MUMBAI METRO RAIL CORPORATION LIMITED (MMRC)

Design, Manufacture, Supply, Installation, Testing and Commissioning of Tunnel Ventilation System & Environmental Control System between Aarey (including) to BKC (including) Stations; TVE Phase-1 (Package:15)

Date: 17th July, 2018]

Addendum No: 3

PROJECT	STATION	DATE
MUMBAI METRO LINE 3 COLABA-BANDRA-SEEPZ	UNDERGROUND STATION	14-03-2018
TITLE	DRAWING TITLE	SCALE
STATION ENVIRONMENTAL CONTROL SYSTEM	WATER FLOW SCHEMATIC - ENVIRONMENTAL CONTROL SYSTEM (SHEET 1 OF 2)	NTS (A1)
DRAWING NO	GCC-TVE-P00-0001-020_A1

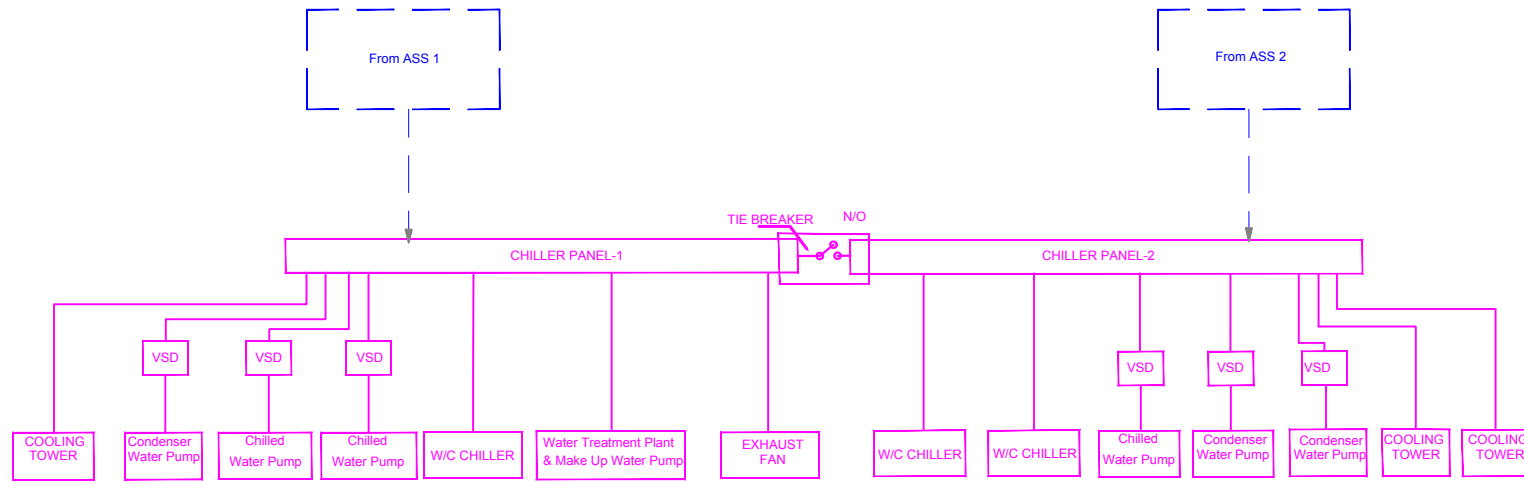
Sr. No.	Description and Clause No.	Amendment
1	Part 4: Drawings Section X, Drawings	<p><u>Replace Station Environmental Control System Drawing</u></p> <p>DRAWING NO.: GCC-TVE-P00-0001-020_A0 DRAWING TITLE: WATER FLOW SCHEMATIC ENVIRONMENTAL CONTROL SYSTEM (SHEET 1 OF 2)</p> <p><u>With</u></p> <p>DRAWING NO.: GCC-TVE-P00-0001-020_A1 DRAWING TITLE: WATER FLOW SCHEMATIC ENVIRONMENTAL CONTROL SYSTEM (SHEET 1 OF 2)</p> <p>See Attachment No. 1 of TVE PHASE-1 Addendum No.3</p>
2	Part 4: Drawings Section X, Drawings	<p><u>Replace Station Environmental Control System Drawing</u></p> <p>DRAWING NO.: GCC-TVE-P00-0001-027_A0 DRAWING TITLE: ELECTRICAL SCHEMATIC DIAGRAM FOR CHILLER PLANT ROOM</p>

REV.	DATE	PREP.	APPROVED	DESCRIPTION
A1	09/08/18	AKS	NC	A/C CHILLER CHILLED WATER PUMP ADDED

Sr. No.	Description and Clause No.	Amendment
		<p><u>With</u></p> <p>DRAWING NO.: GCC-TVE-P00-0001-027_A DRAWING TITLE: ELECTRICAL SCHEMATIC DIAGRAM FOR CHILLER PLANT ROOM</p> <p>See Attachment No. 2 of TVE PHASE-1 Addendum No.3</p>
3	Part 4: Drawings Section X, Drawings	<p><u>Replace Station Environmental Control System Drawing</u></p> <p>DRAWING NO.: GCC-TVE-P00-0001-026_A0 DRAWING TITLE: ELECTRICAL SCHEMATIC DIAGRAM FOR ECS</p> <p><u>With</u></p> <p>DRAWING NO.: GCC-TVE-P00-0001-026_A DRAWING TITLE: ELECTRICAL SCHEMATIC DIAGRAM FOR CHILLER PLANT ROOM</p> <p>See Attachment No. 3 of TVE PHASE-1 Addendum No.3</p>
4	Part 2: Employer’s Requirements, Section VI-B1, Technical Specifications for Environmental Control System Clause: 5.3.5 Page: 23 of 145	<p><u>Replace</u></p> <p>“Retail areas shall be provided with “Warm Shell” ECS except Sidhivinayak station Intermediate Level and retail in unpaid areas at both Cuffe Parade and BKC stations. The provisions shall include chilled water supply and return pipe connections with energy meter and motorized valves; and, fresh air supply duct terminated at the boundary of each retail zone under 200m². For retail zone larger than 200m², the “Warm Shell” provision shall be provided for every 200m². SCADA system shall log the usage of the cooling energy and report to MMRC for billing purpose. Chilled water shall be provided during revenue service hours.”</p> <p><u>With</u></p>

PROJECT	MUMBAI METRO LINE 3 COLABA-BANDRA-SEEPZ	STATION	ANCILLARY BUILDING/ UNDERGROUND PLANTROOM	DATE	08-02-2018
TITLE	STATION ENVIRONMENTAL CONTROL SYSTEM	DRAWING TITLE	ELECTRICAL SCHEMATIC DIAGRAM FOR CHILLER PLANT ROOM	SCALE	NTS (A1)
DRAWING NO	GCC-TVE-P00-0001-027_A1

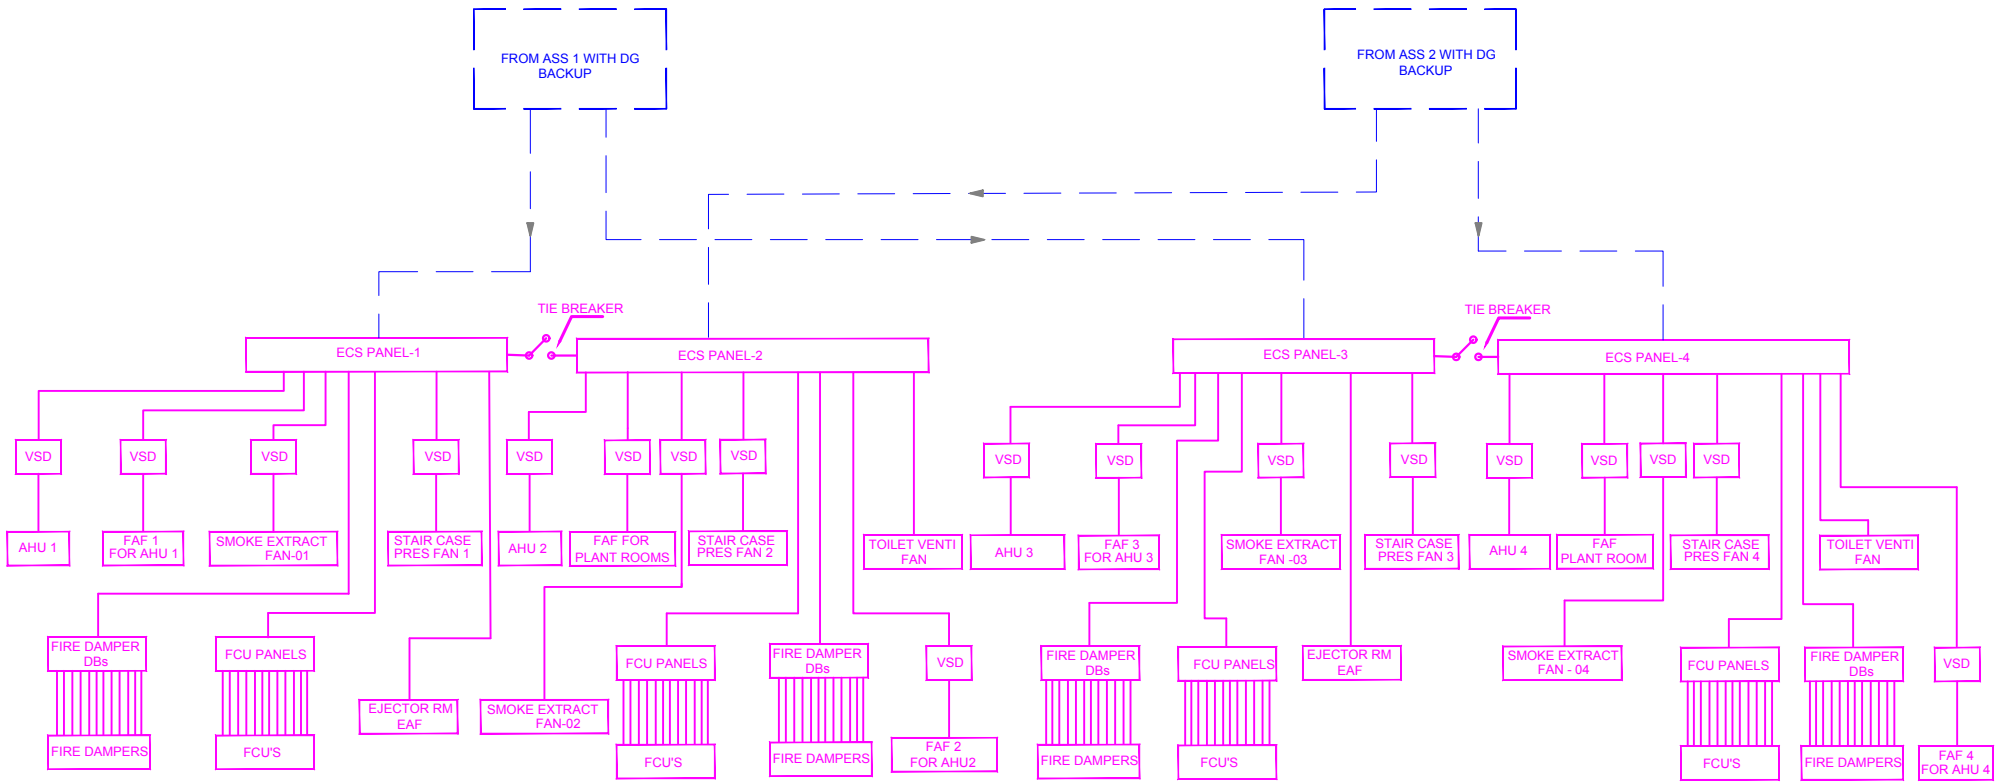
REV.	DATE	PREP.	APPROVED	DESCRIPTION
A1	08/06/18	AKS	NC	CHILLED WATER PUMP FOR A/C CHILLER ADDED

PROJECT	STATION	DATE
MUMBAI METRO LINE 3 COLABA-BANDRA-SEEPZ	ANCILLARY BUILDING	13-04-2018
TITLE	DRAWING TITLE	SCALE
GENERAL ARRANGEMENT DRAWING	PLAN/SECTION/ELEVATION	1:250 (A1)
DRAWING NO	MM3-GC-AR-ANC-1081301-R1

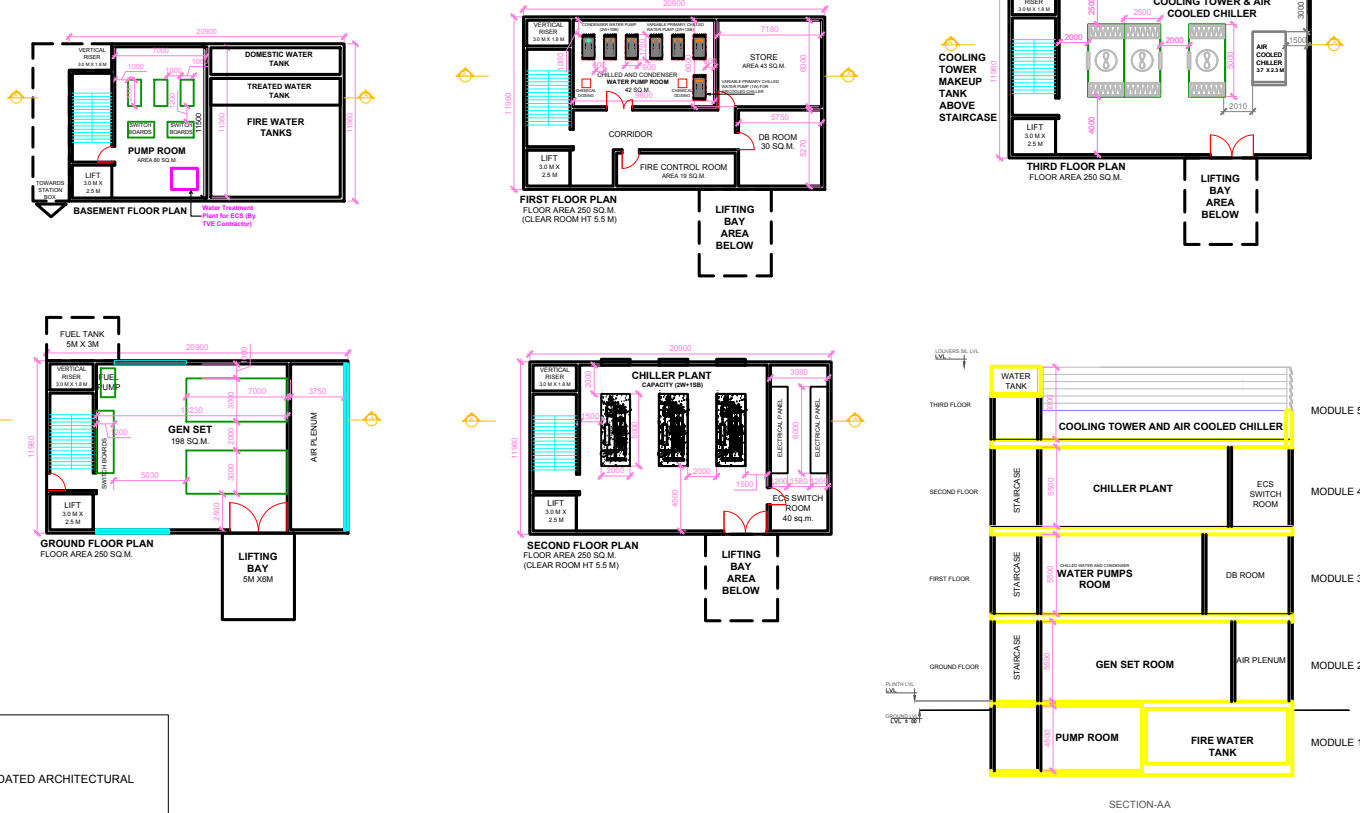
REV.	DATE	PREP.	APPROVED	DESCRIPTION
A1	23/06/18	AKS	NC	NOTES REVISED

Sr. No.	Description and Clause No.	Amendment
		<p>“Retail areas shall be provided with “Warm Shell” ECS except Sidhivinayak station Intermediate Level. The provisions shall include chilled water supply and return pipe connections with energy meter and motorized valves; and, fresh air supply duct terminated at the boundary of each retail zone under 200m². For retail zone larger than 200m², the “Warm Shell” provision shall be provided for every 200m². SCADA system shall log the usage of the cooling energy and report to MMRC for billing purpose. Chilled water shall be provided during revenue service hours.”</p>
5	Part 4: Drawings Section X, Drawings	<p><u>Replace Station Ancillary Building Drawing</u></p> <p>DRAWING NO.: MM3-GC-AR-1081301-R0 DRAWING TITLE: PLAN/SECTION/ELEVATION</p> <p><u>With</u></p> <p>DRAWING NO.: MM3-GC-AR-1081301-R1 DRAWING TITLE: PLAN/SECTION/ELEVATION</p> <p>See Attachment No. 4 of TVE PHASE-1 Addendum No.3.</p>

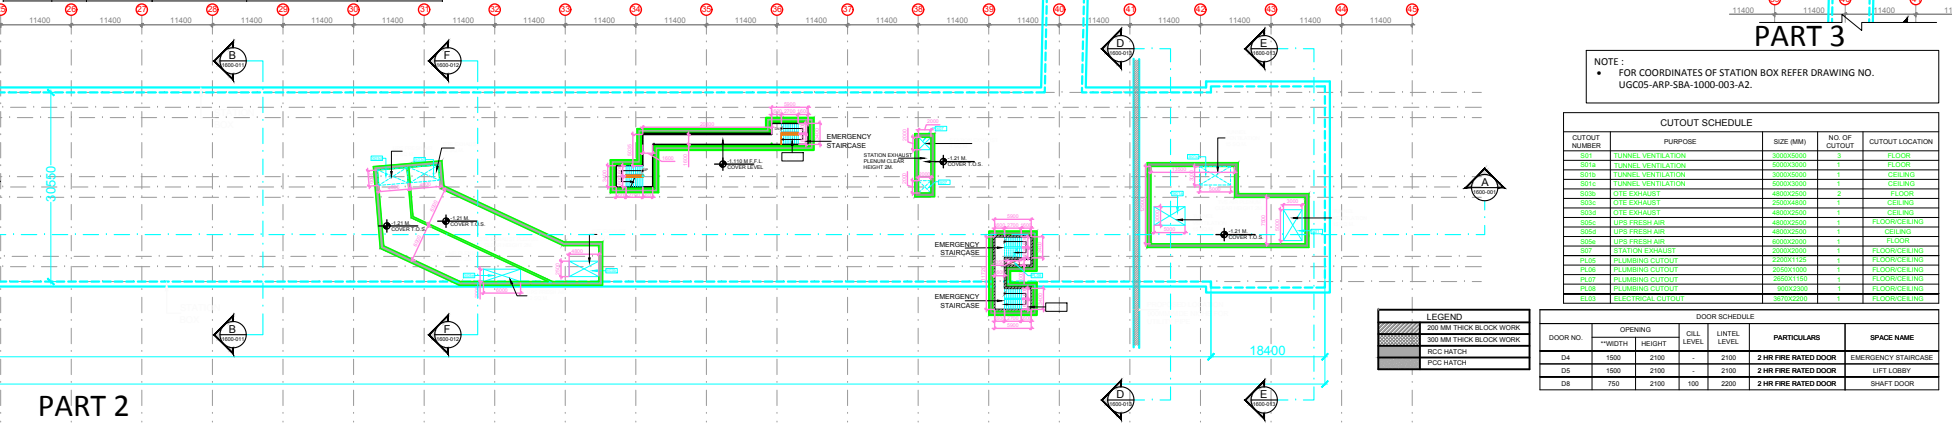
13	<p>Part 4: Drawings Section X, Drawings</p>	<p><u>Replace following drawings of BKC station:</u></p> <p>UGC05-ARP-SBA-1000-001-A4-P UGC05-ARP-SBA-1100-001-A3-P UGC05-ARP-SBA-1200-001-A2-P UGC05-ARP-SBA-1300-001-A3-P UGC05-ARP-SBA-1400-001-A3-P UGC05-ARP-SBA-1500-001-A3-P UGC05-ARP-SBA-1600-001-A3-P UGC05-ARP-SBA-1600-011-A3-P UGC05-ARP-SBA-1600-012-A3-P</p>

Sr. No.	Description and Clause No.	Amendment																																																
		<p><u>With the following drawings of BKC station:</u></p> <p>UGC05-ARP-SBA-1000-001-A7-D UGC05-ARP-SBA-1100-001-A6-D UGC05-ARP-SBA-1200-001-A5-D UGC05-ARP-SBA-1300-001-A7-D UGC05-ARP-SBA-1400-001-A6-D UGC05-ARP-SBA-1500-001-A6-D UGC05-ARP-SBA-1600-001-A6-D UGC05-ARP-SBA-1600-011-A4-D UGC05-ARP-SBA-1600-012-A4-D</p> <p>Refer Attachment No. 7 of TVE PHASE-1 Addendum No.3.</p>																																																
14	Part 2: Employer’s Requirements, Section VI-B1, Technical Specifications for Environmental Control System Table: 6.1 Page: 36 of 145	<p><u>Replace Table 6.1: Air conditioning required rooms</u></p>
